**ADDENDUM NO3**Date: **April 8, 2026**Project No.: **2596**Project: **Alderville Senior's Residence  
Renovations**

The following information, amendments and revisions shall constitute Addendum No 3, and shall form an integral part of the Tender Documents and where applicable, shall supersede requirements of other Tender Documents.

**A-3.0**

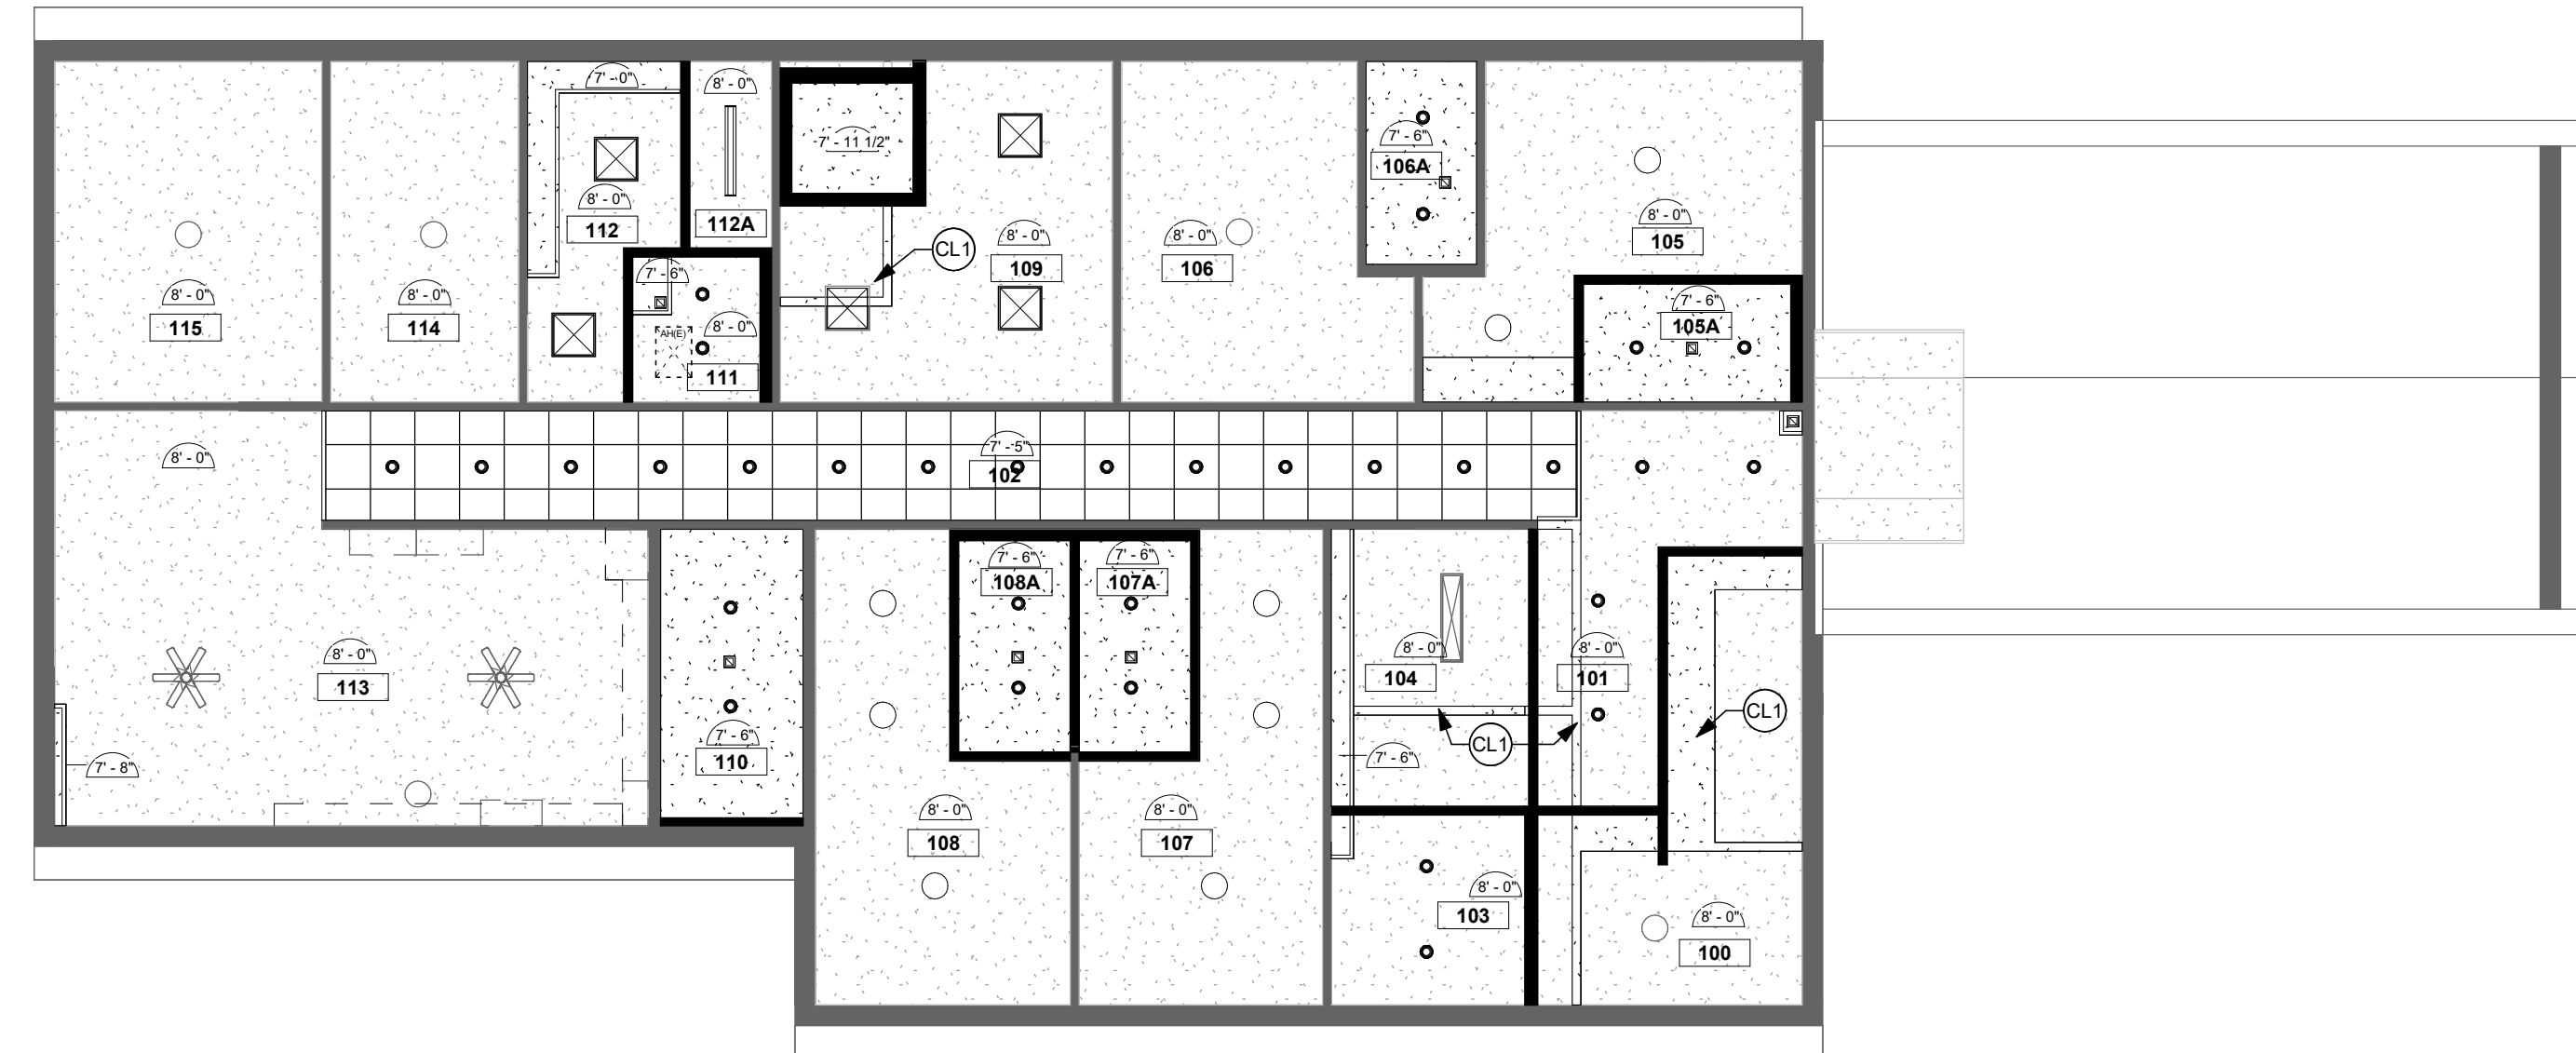
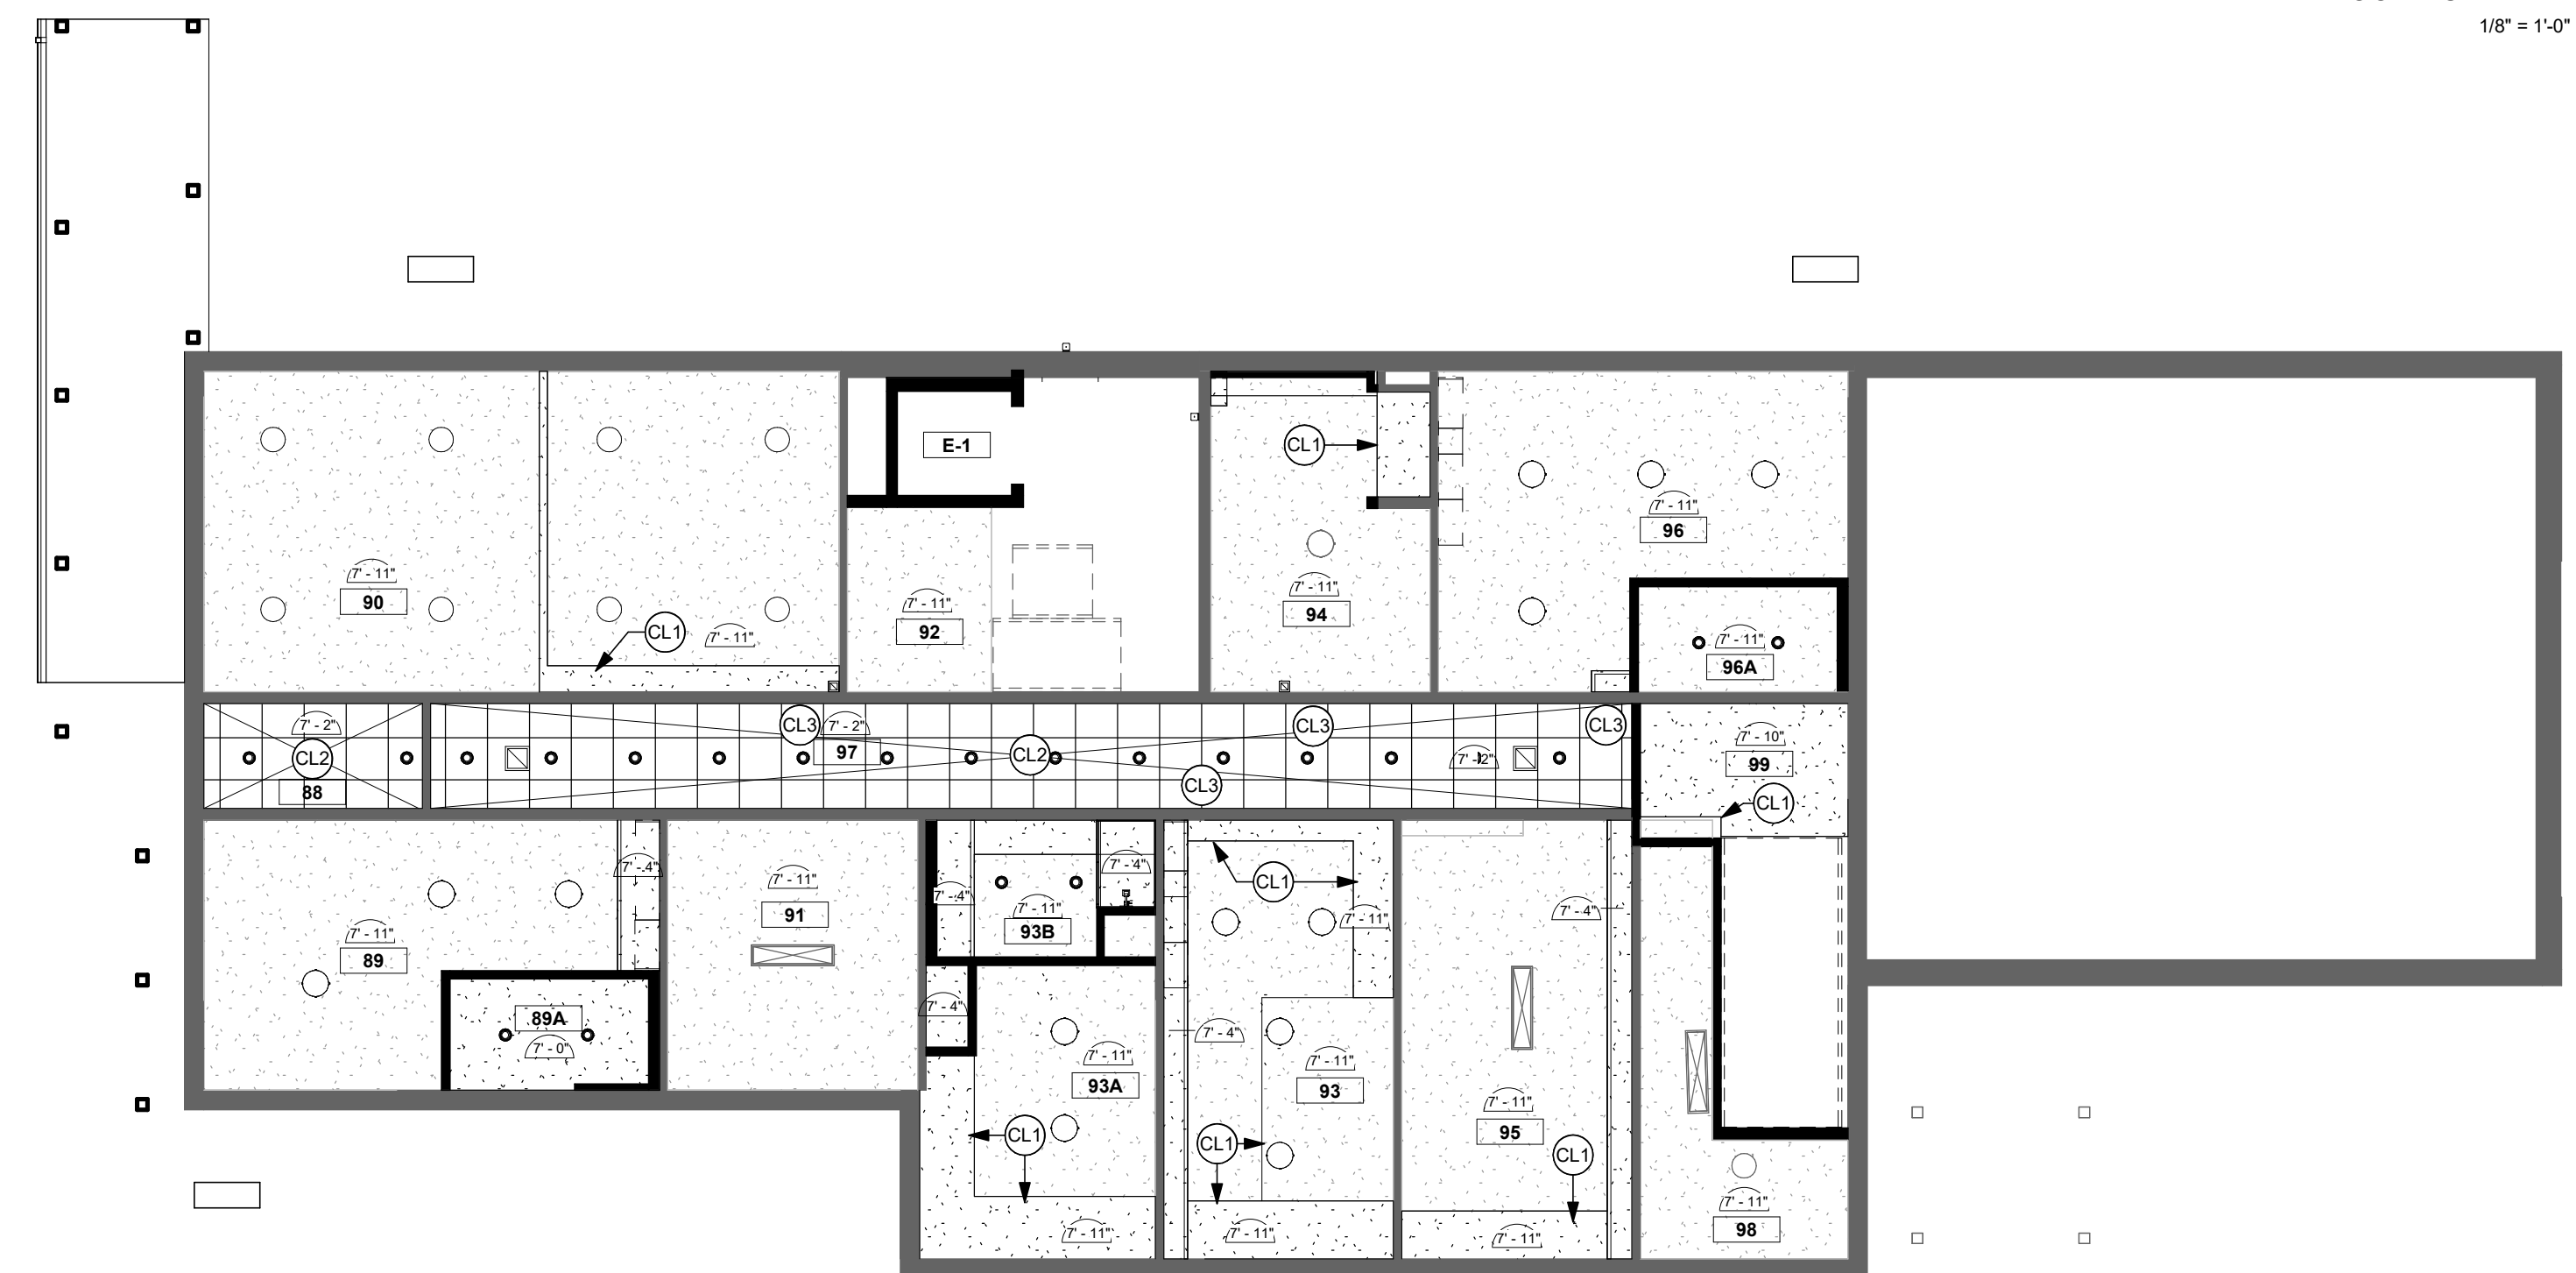
**3.10** **Question:** Drawing A3.0 - CLG2 notes 1/2 gypsum board to basement corridor ceiling. Detail 1/A6.1 notes 5/8 gypsum board to corridor ceiling. Can you please confirm which we are to carry?ds to be framed in wood or steel studs?

**3.11** **Question:** Drawing A3.0 - CLG3 is not noted on drawings. Can you please confirm where we are to apply this assembly?

**Answer: Contractor to use 5/8" gypsum board as per detail 1/A6.1. It is to be fastened directly to existing floor joists.**

**Answer: Note CL3 applies to basement level ceiling where ductwork runs in floor joist space. Refer also to answer to question 3.10. Refer also to mechanical drawings.**

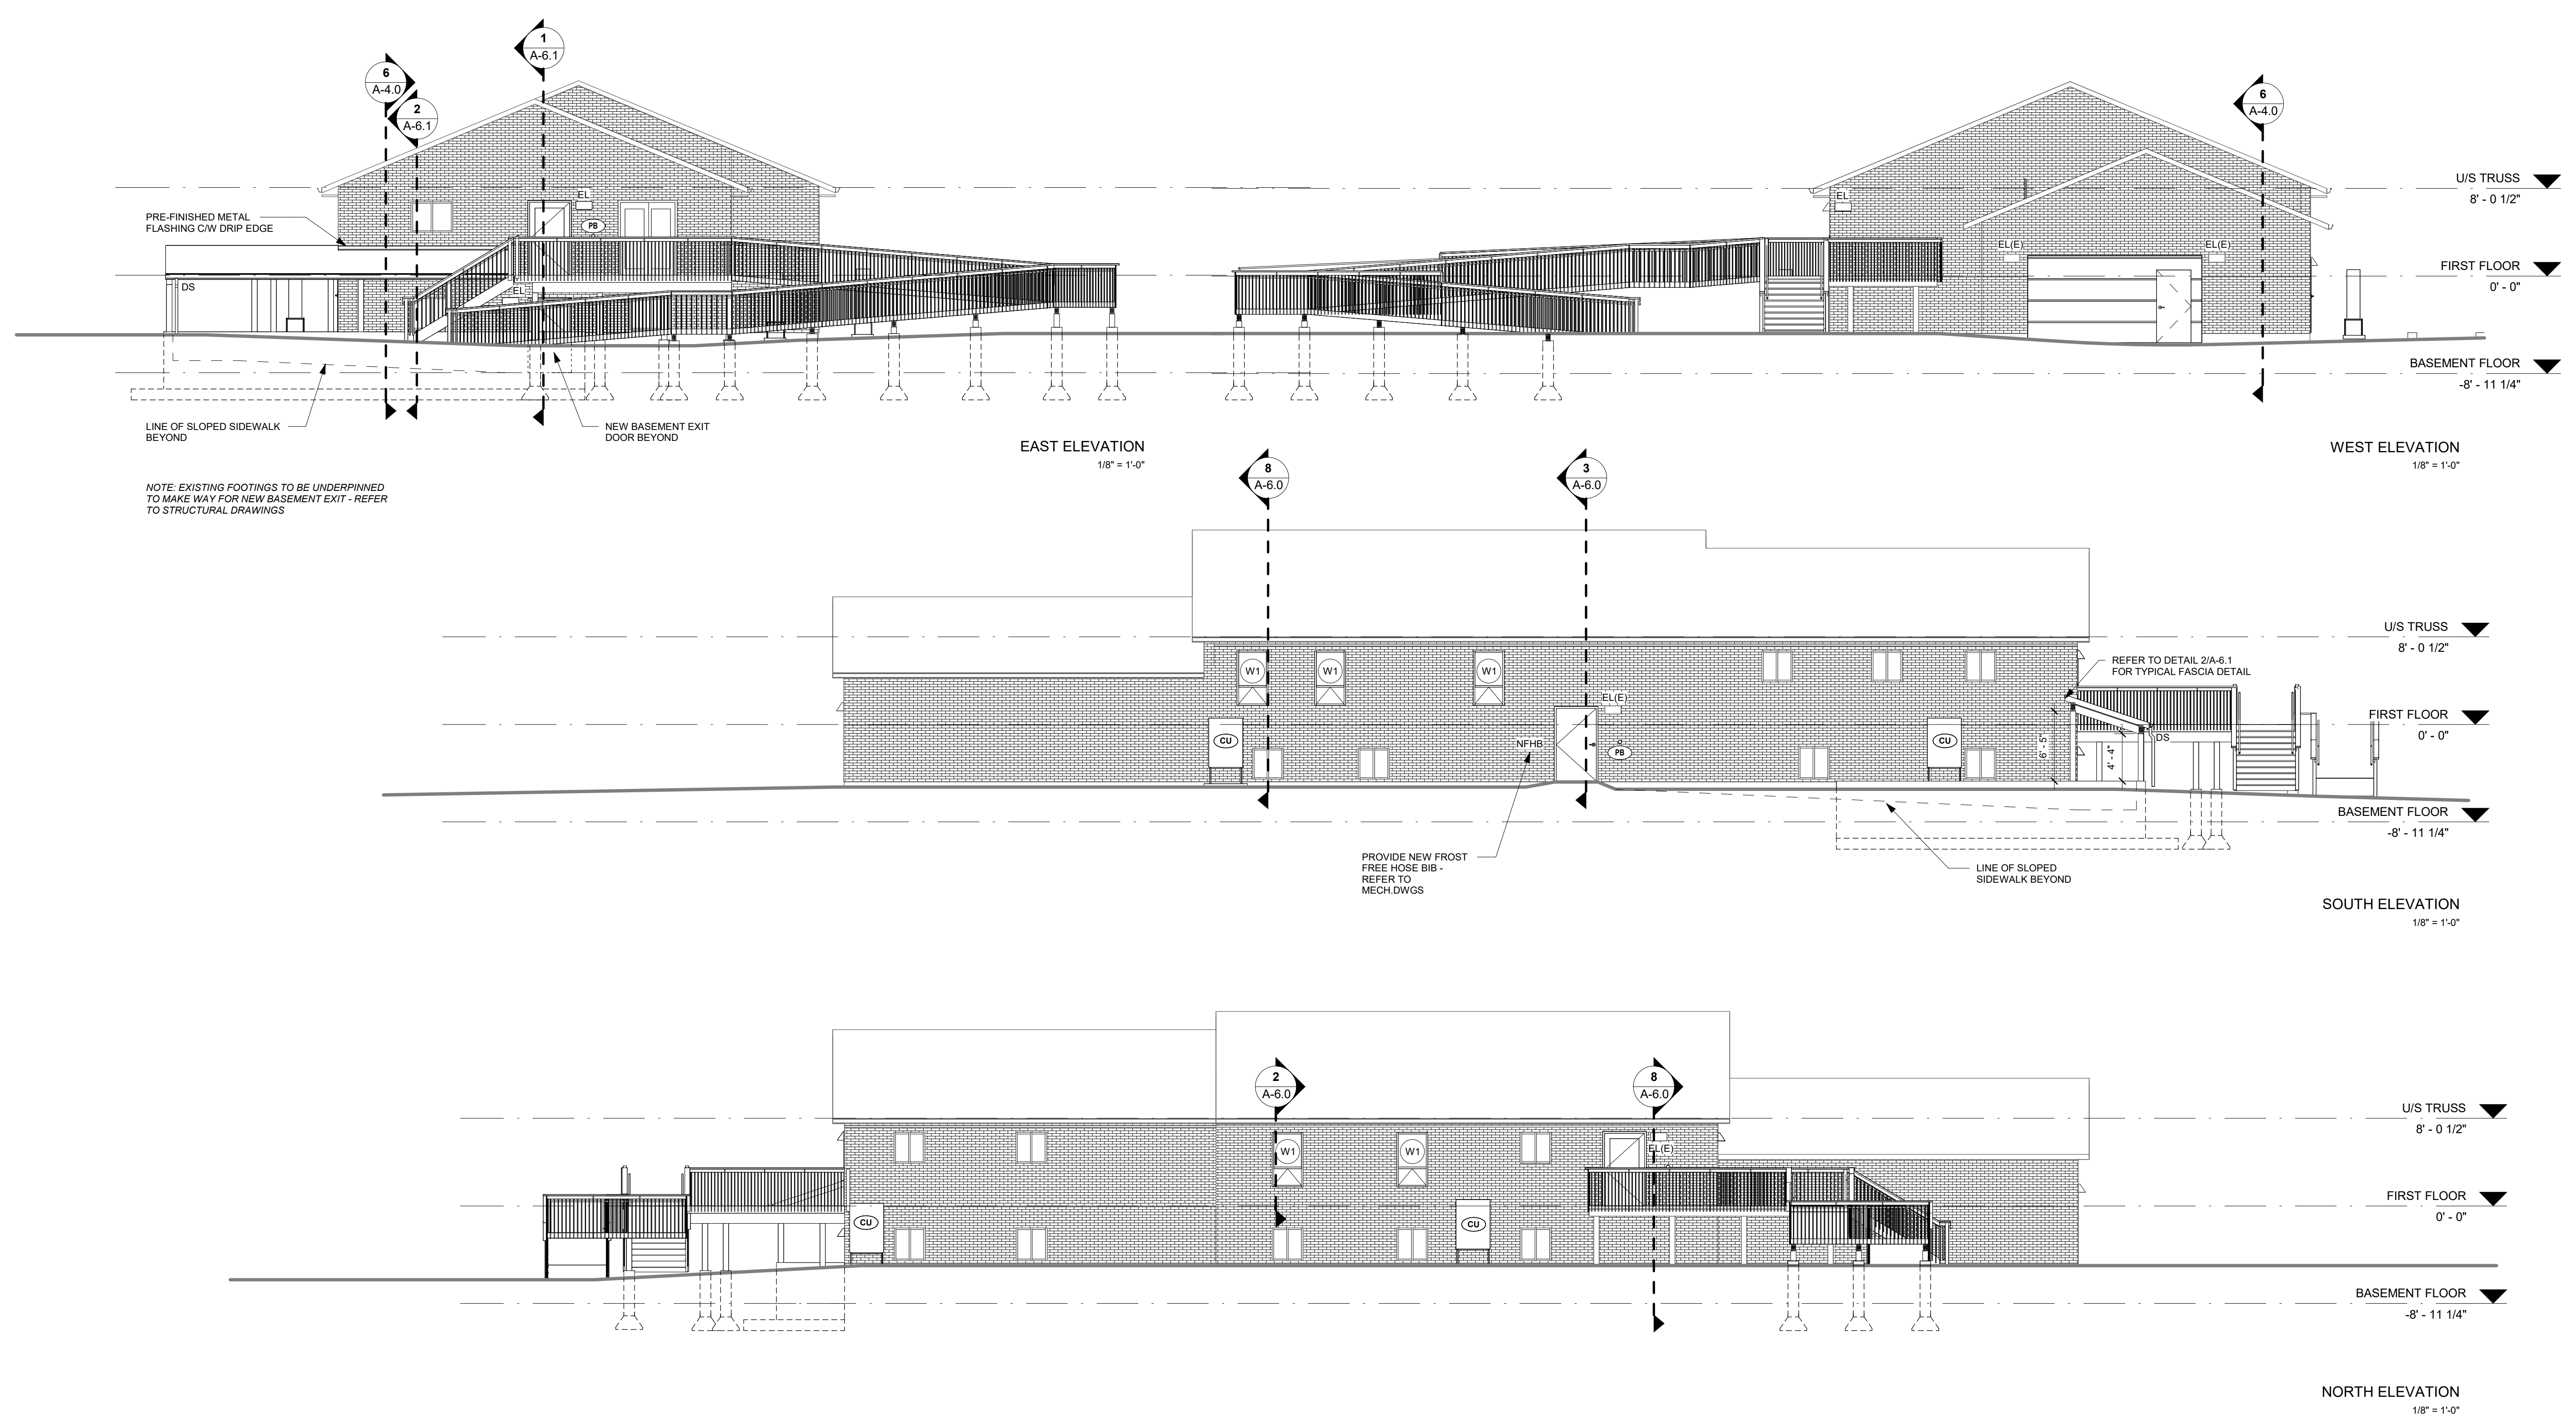
**3.27 Question:** On Building Elevation drawing A5.0 (East Elevation), underpinning is noted for the footing and foundation wall supporting the canopy. The entry to this walkway is by a man door; however, the East Elevation only shows windows and no man door. Can you please confirm that this is the correct location for this construction?

**Answer: New walkway leads to new basement exit door on the east elevation. Refer also to revised A-5.0 – Building Elevations attached to this addendum.**
